ADDENDUM NO. 2

Issued by: Sacramento City Unified School District

Project: Project #: 0029-401 Bret Harte Playground

| DSA STAMP | | |
|--|--|--|
| GRADING PLAN | | |

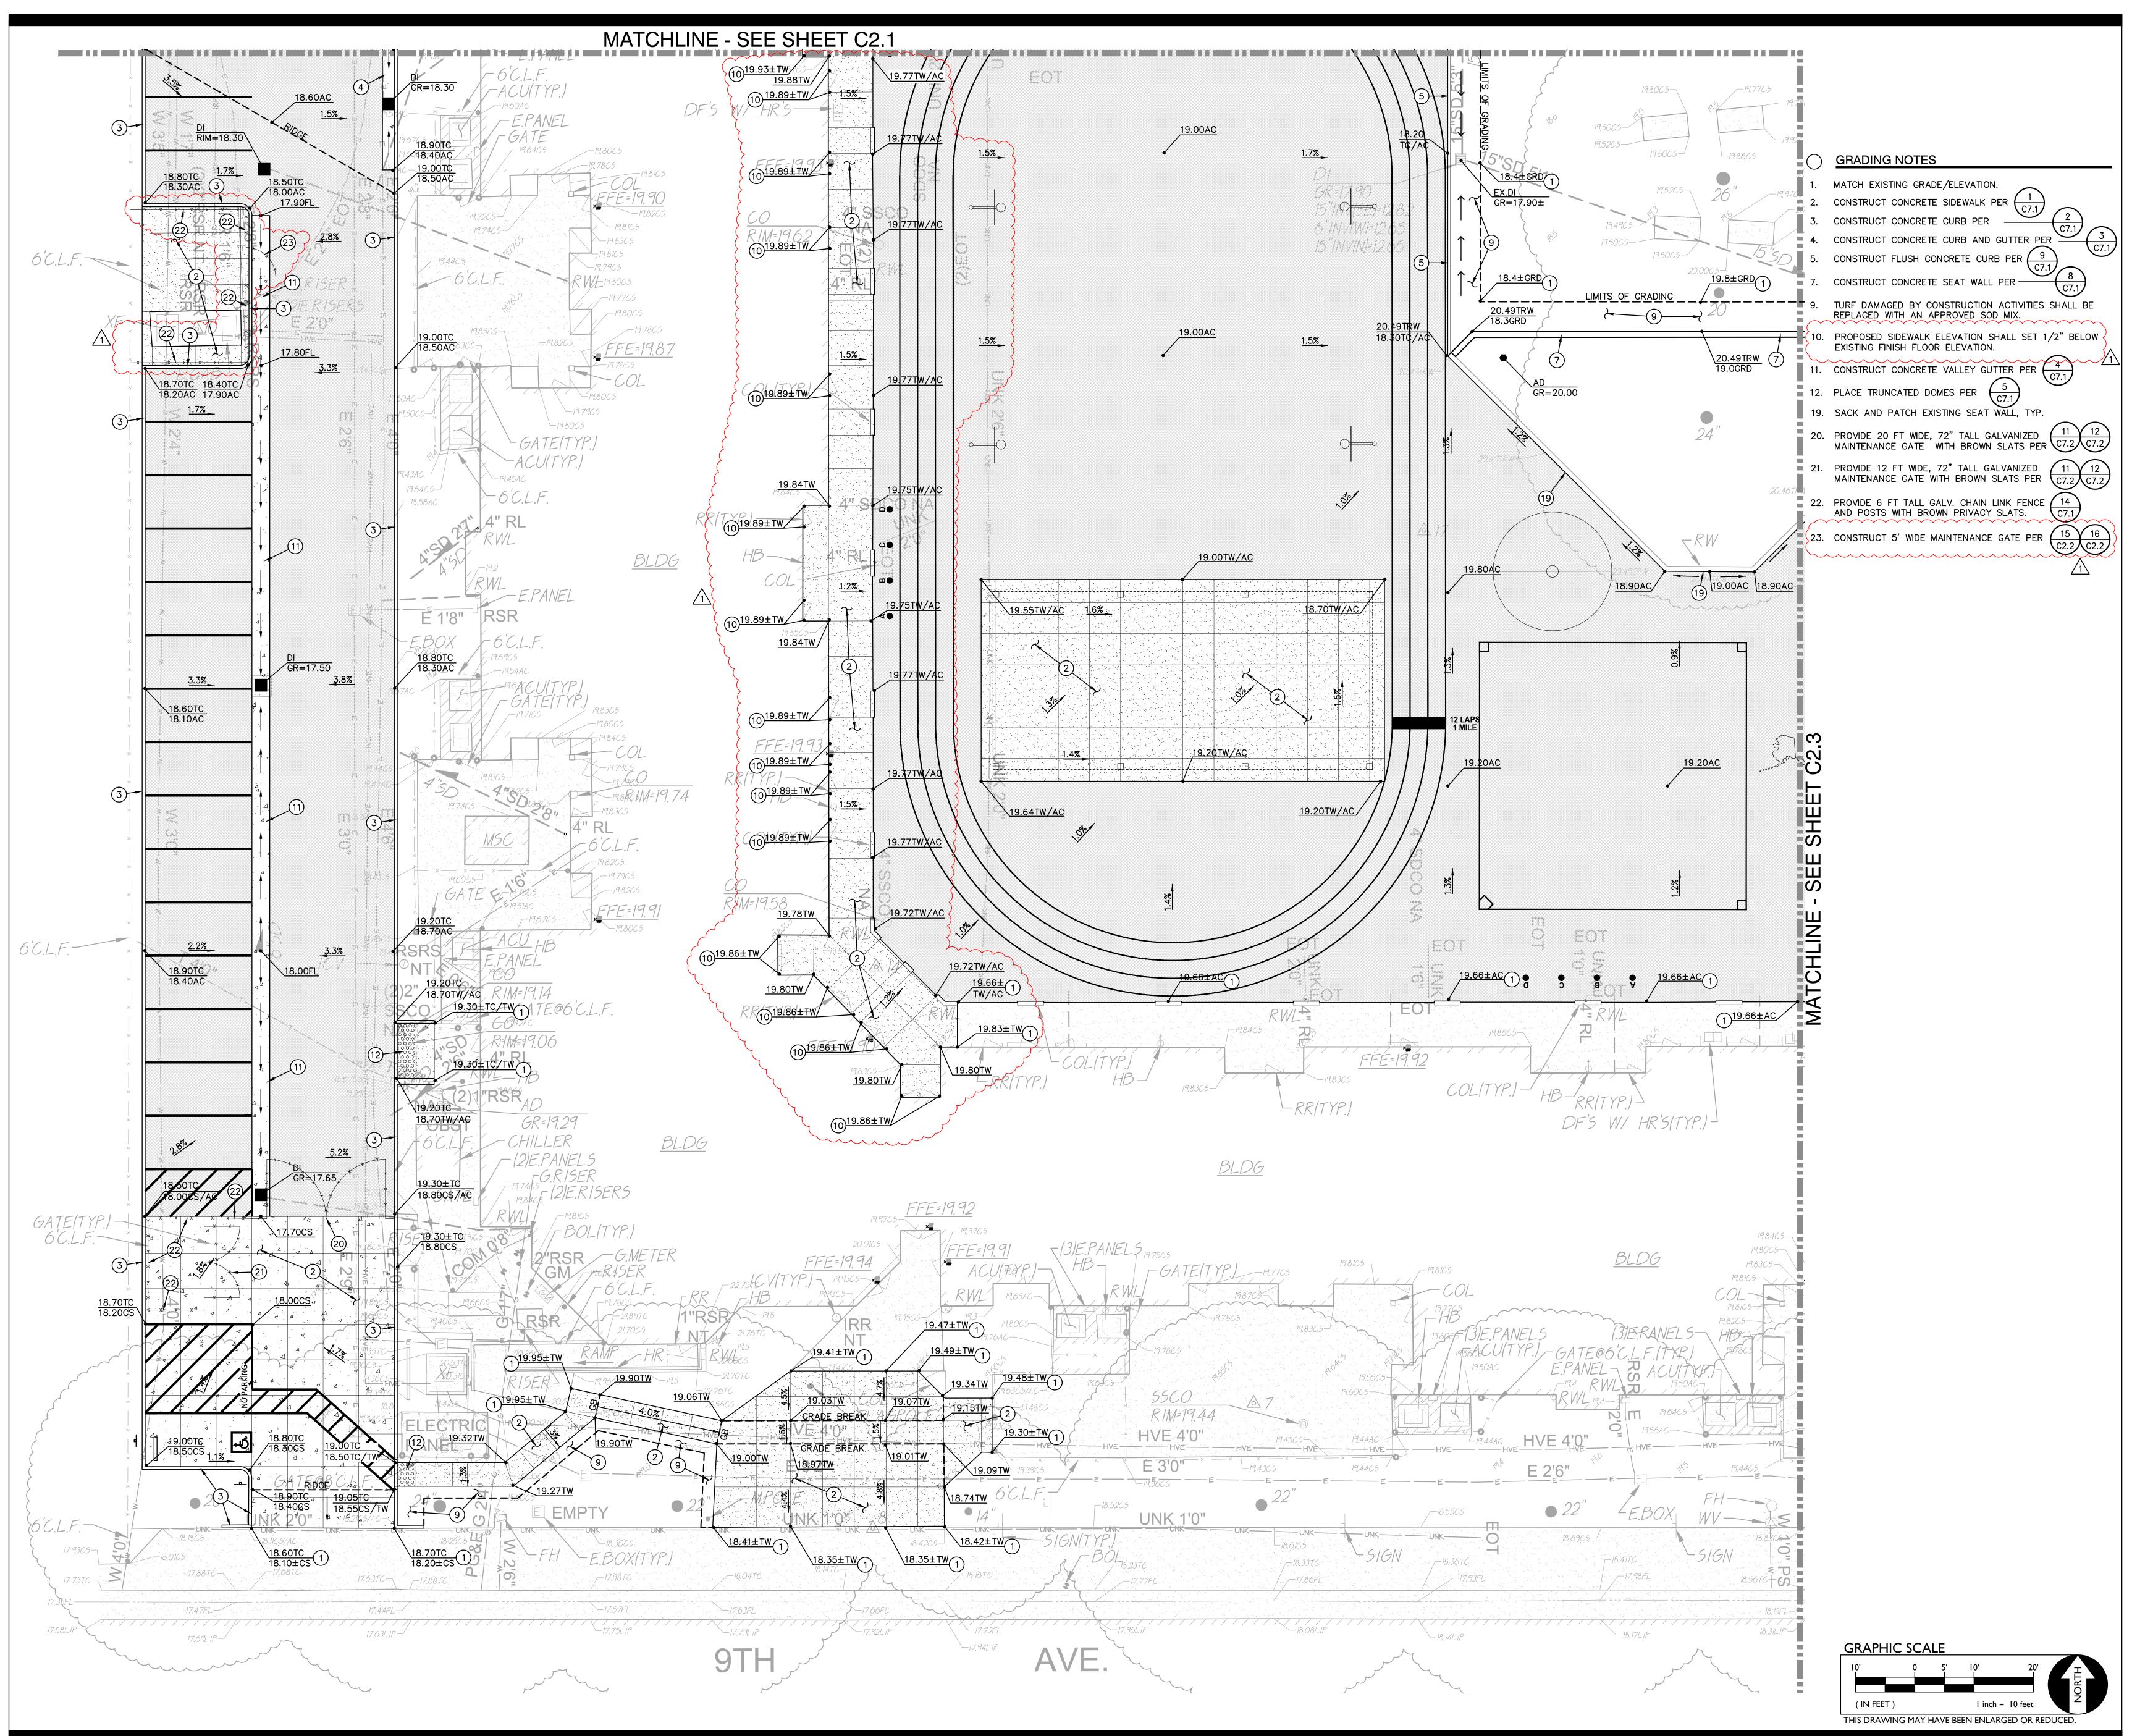
- 2. Grading elevation revisions at Building 001
- G. SHEET C2.2:
 - 1. Add chain-link fence and gate to new enclosure in new parking lot
 - 2. Grading elevation revisions at east side of Building 001

- 3. Revision to note 10 under Grading Notes
 - 4. Add note 23 under Grading Notes
- H. SHEET C2.3:
 - 1. Note 17 under Grading Notes to include new knox lock/box to new gate off of Franklin Blvd

| DSA STAMP | | |
|--|--|--|
| Date 01/24/2023 Scale AS SHOWN Drawn Checked | Project Number 22035 Drawing Number C2.3 | |

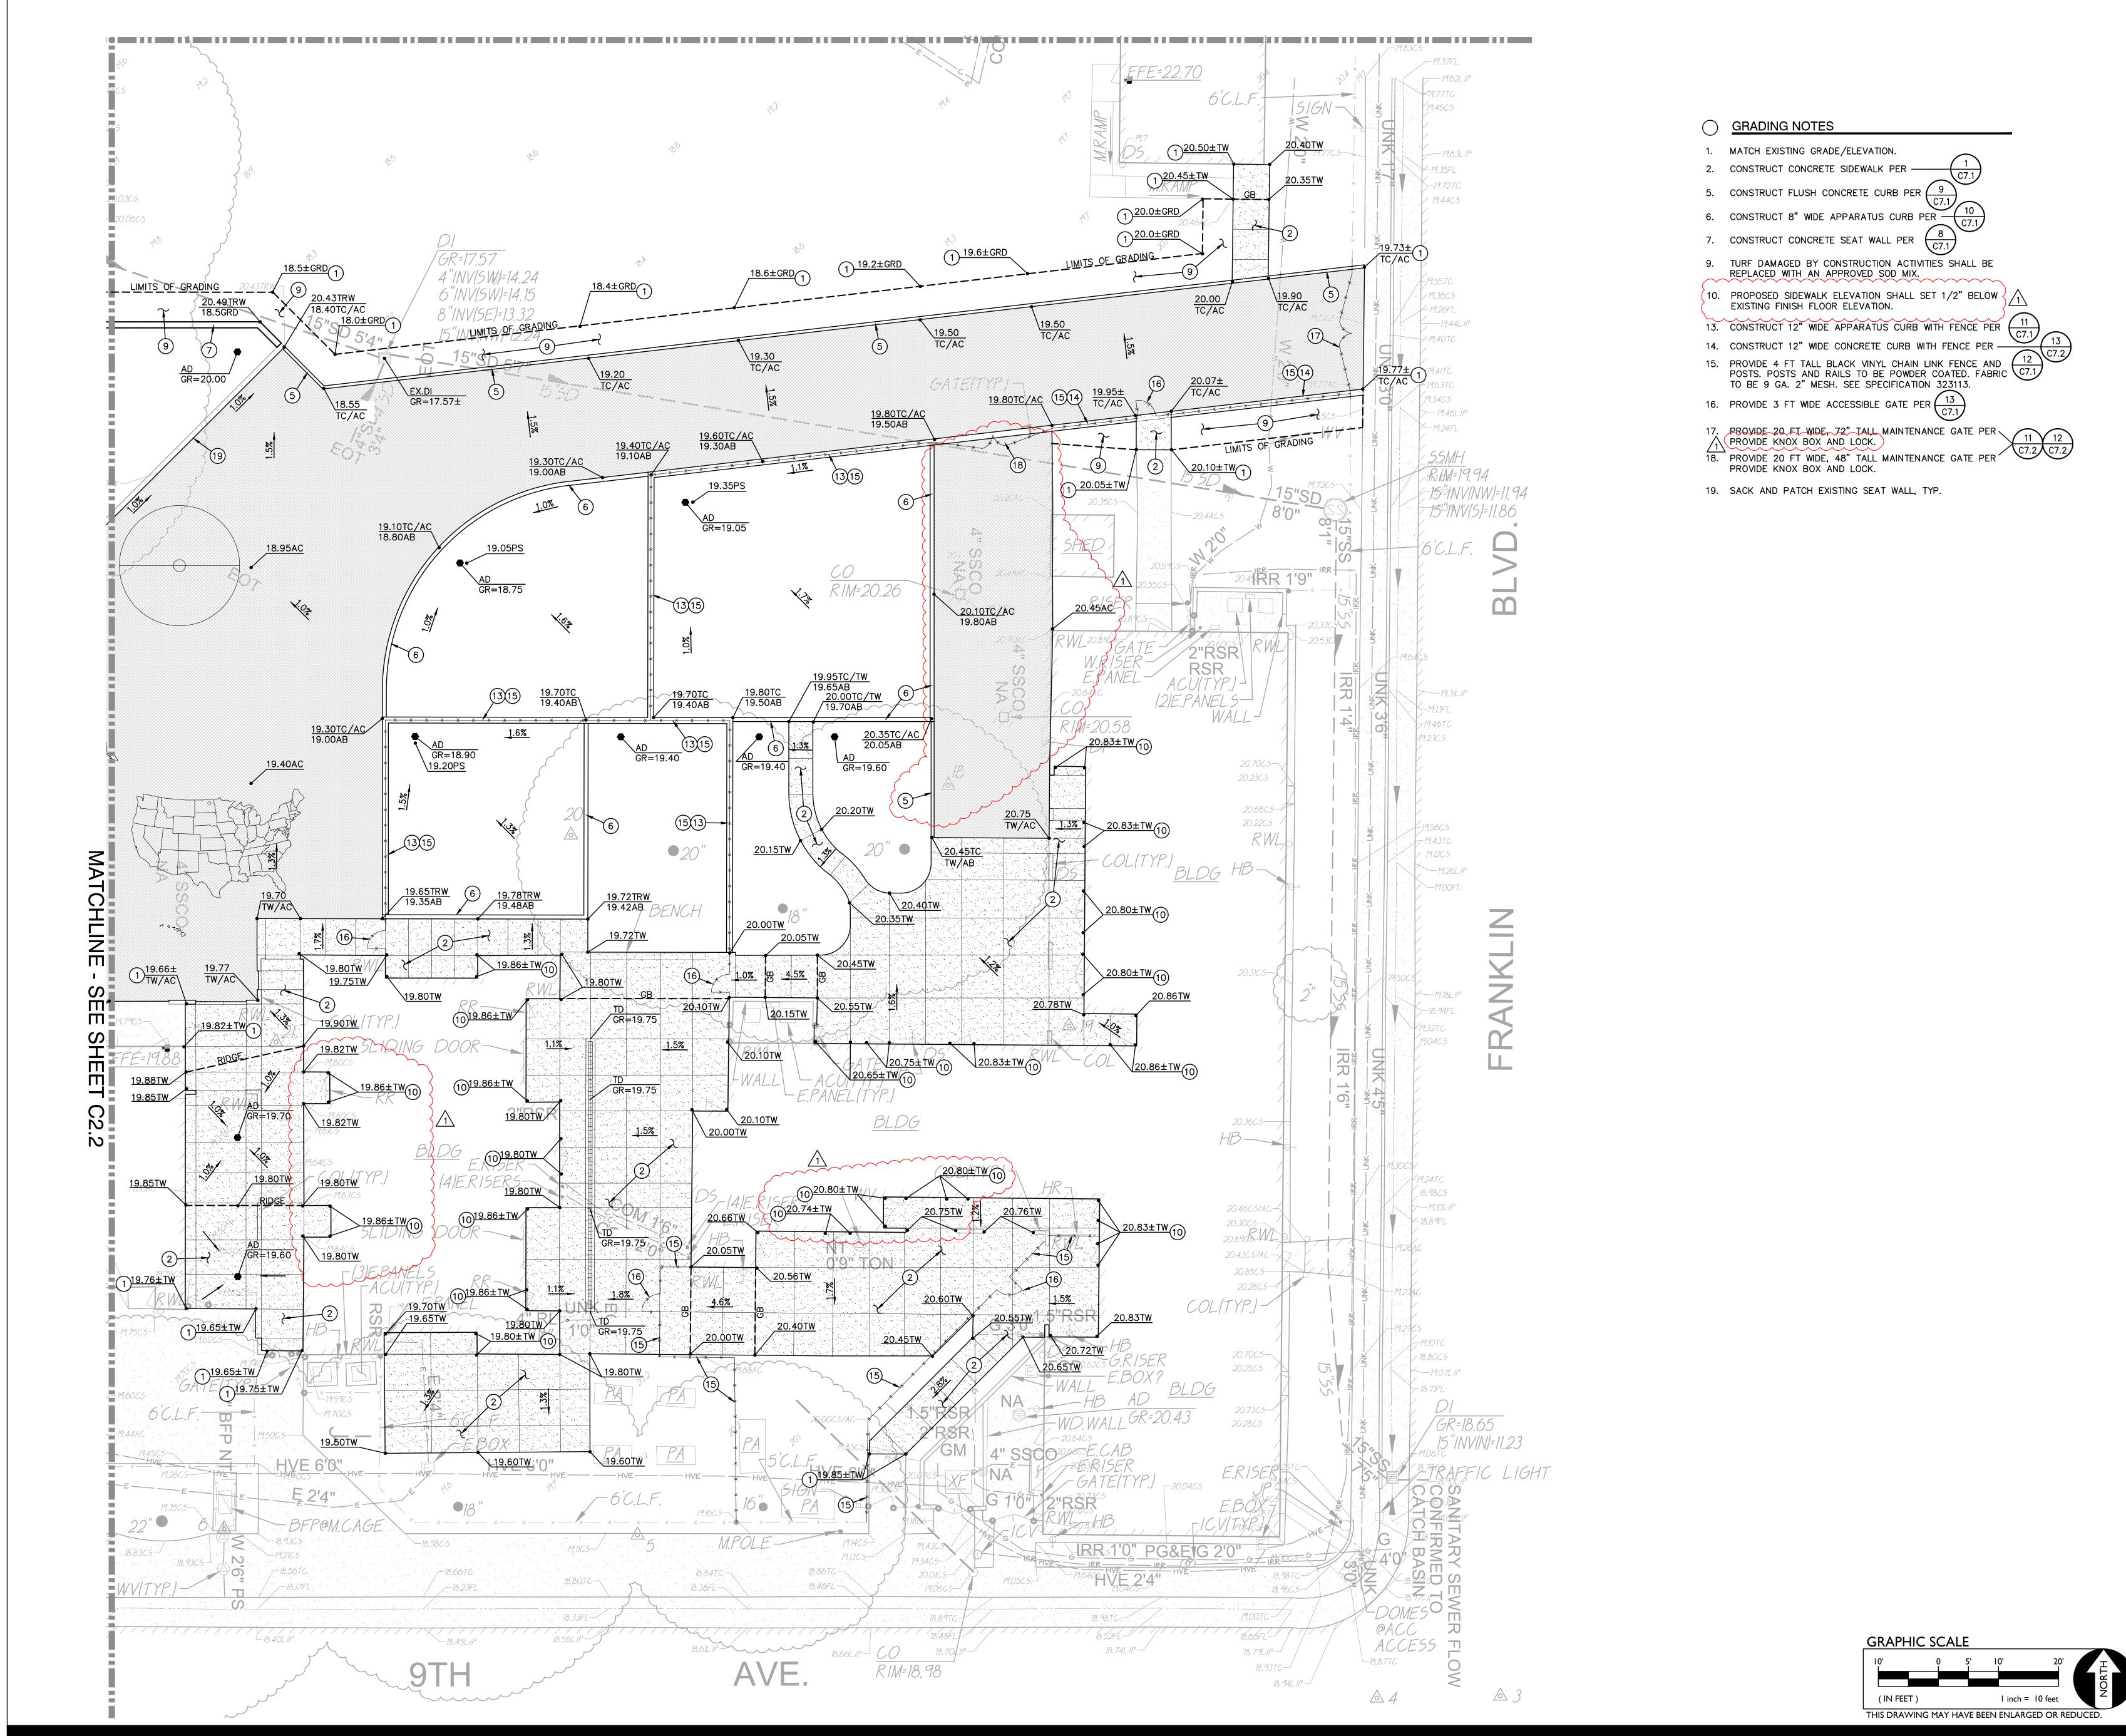
- 2. Revision to note 10 under Grading Notes
 - 3. Grading elevation revisions at west side of Building 001 and north side of Building 003
 - 4. New AC paving added adjacent to shed

| DSA STAMP | | |
|---|--|--|
| Date 01/24/2023 Scale AS SHOWN Drawn Checked AT AT | Project Number 22035 Drawing Number C3.1 | |

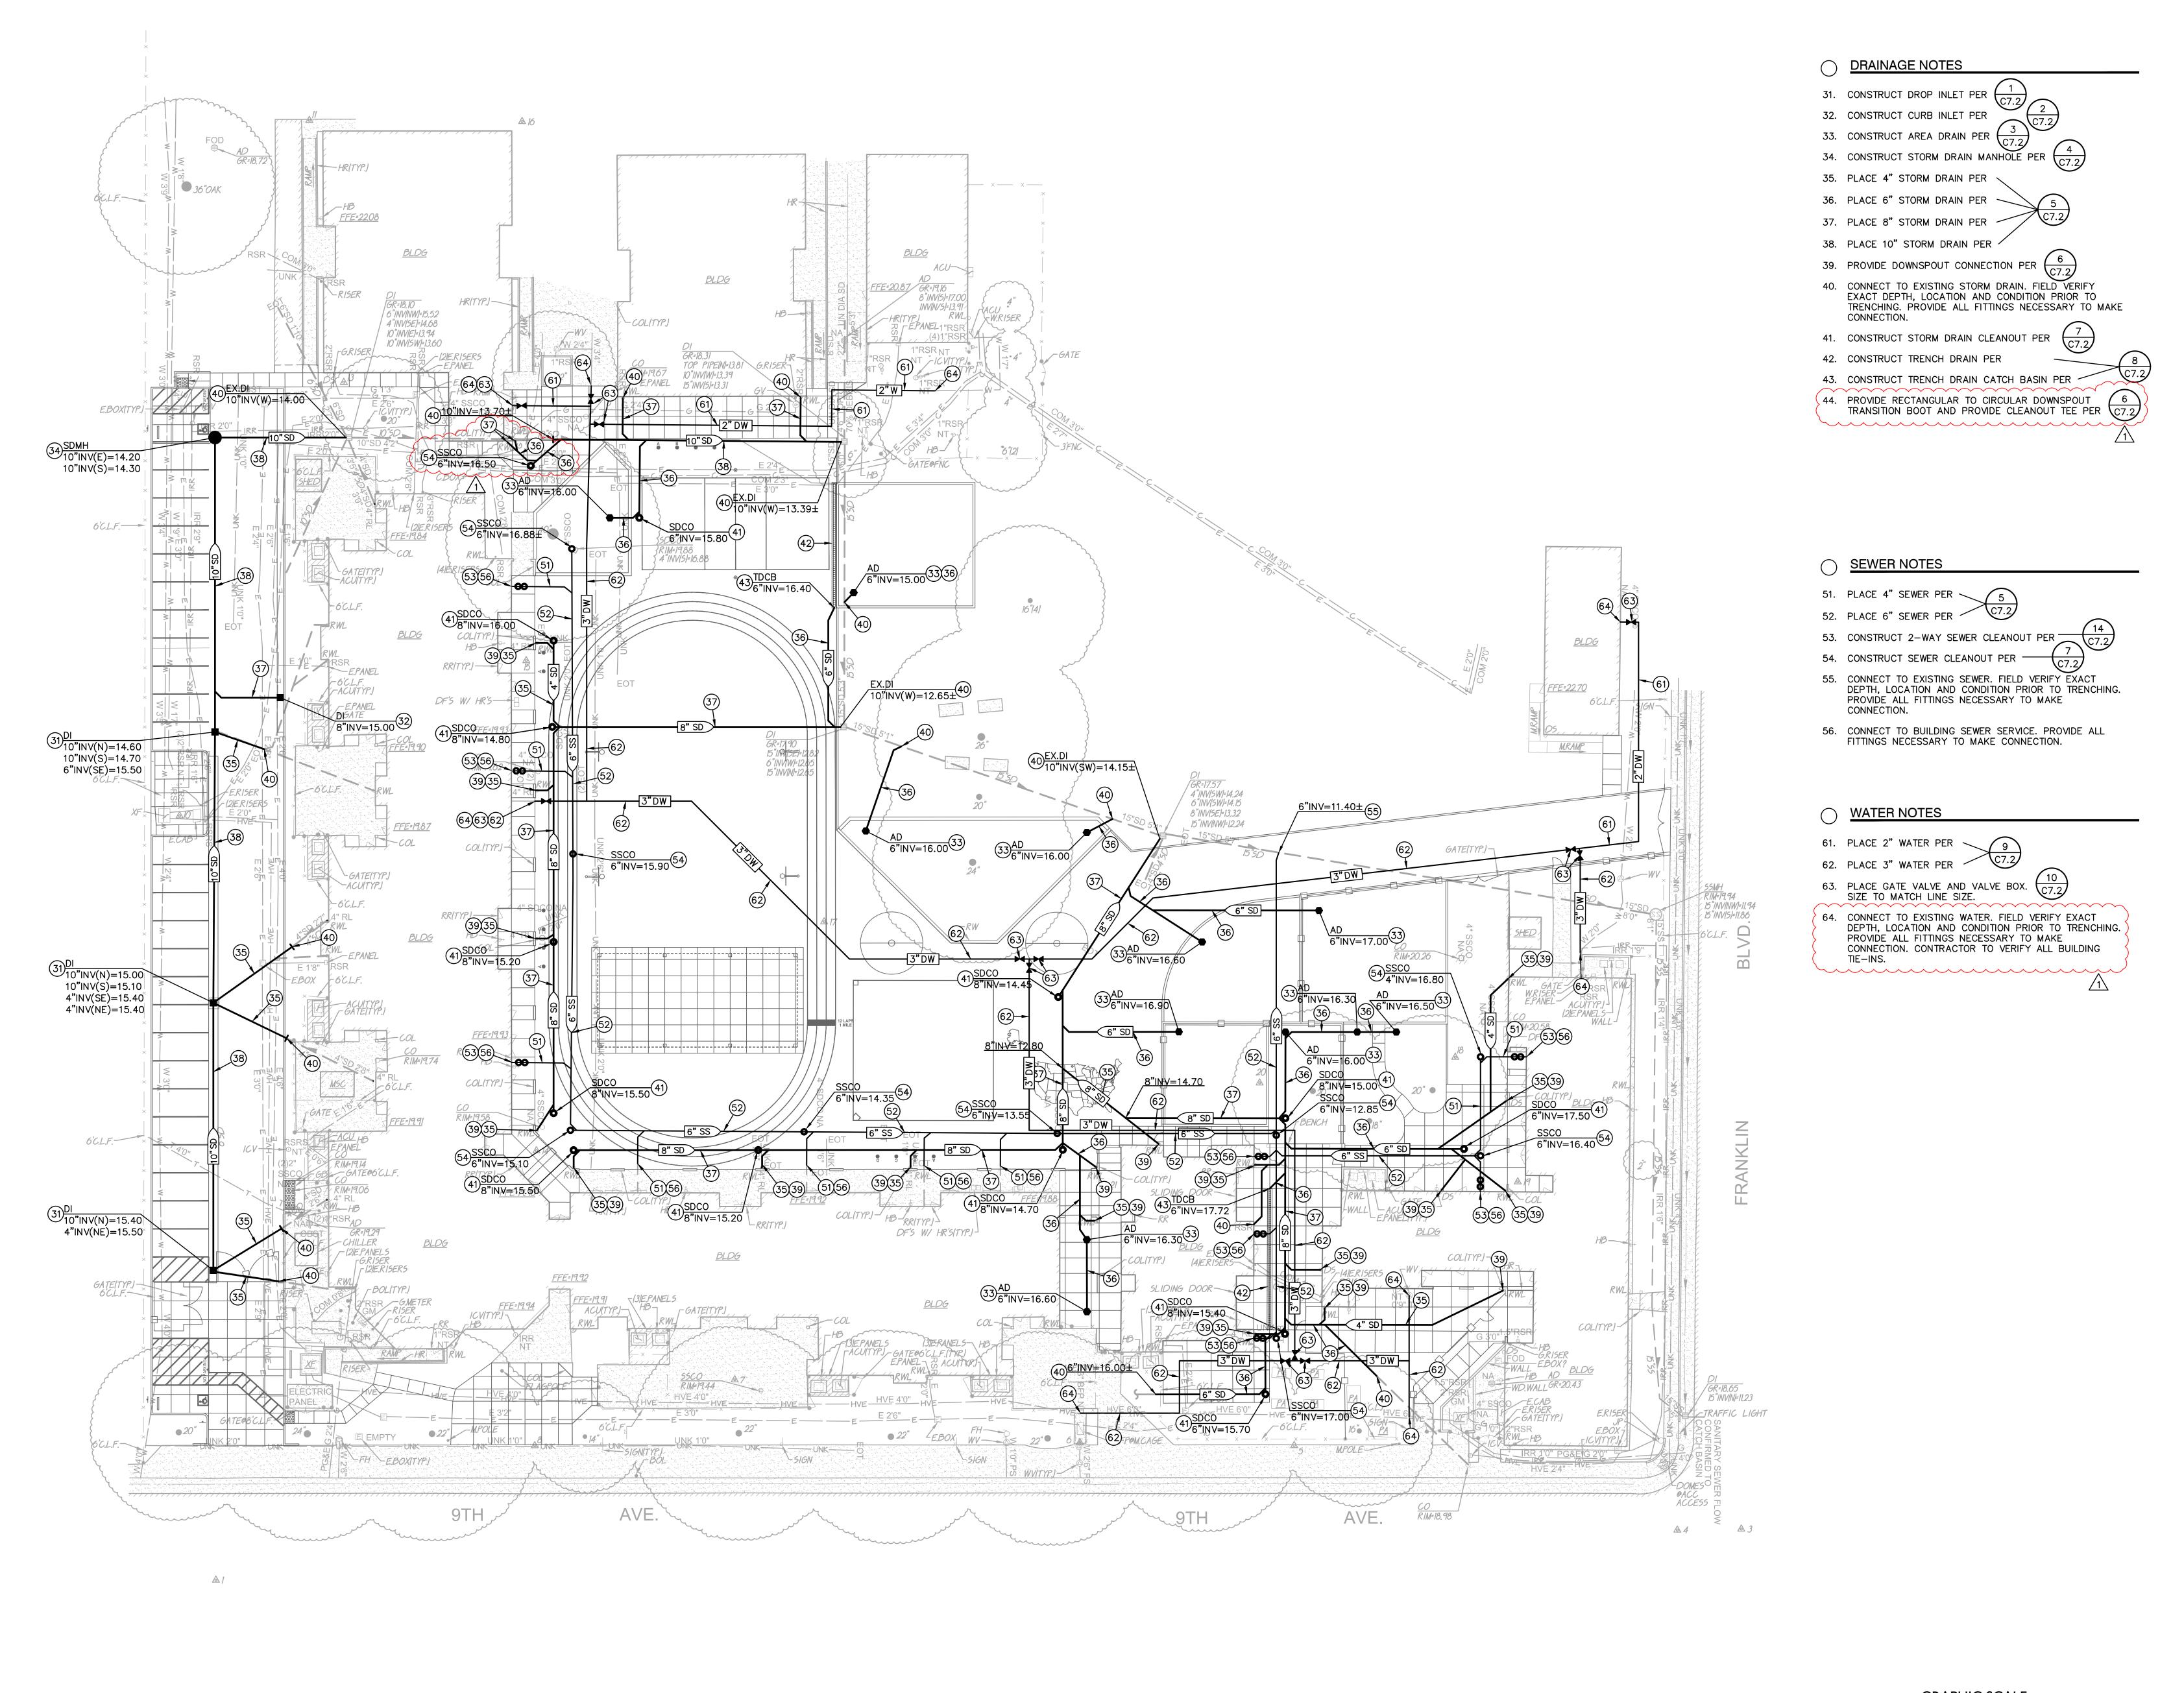
- I. SHEET C3.1:
 - 1. Added verbiage to Water Notes #
 - 2. Add note 44 under Drainage Notes
 - 3. Revision of utilities at north west corner of Building 001
